Office Action Summary

10/566,639

BONNER, MICHAEL R.

DETAILED ACTION

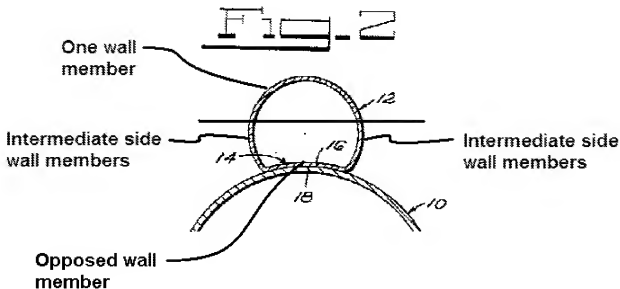
Collito (Figure 2, marked up, next page) discloses a conduit assembly comprising two conduit members 12 having an elongate, flexible fluid-tight wall having at least two opposed wall members, one wall member has a convex outer surface, an opposed wall member has a concave outer surface 16 and intermediate side wall members (i.e. delineated by the line) interposed there between, defining a non-circular cross section; but does not disclose a polymeric material and a rib/tab.

Regarding claim 21-22, Figure 2 of Collito discloses the first and second walls are arcuate.
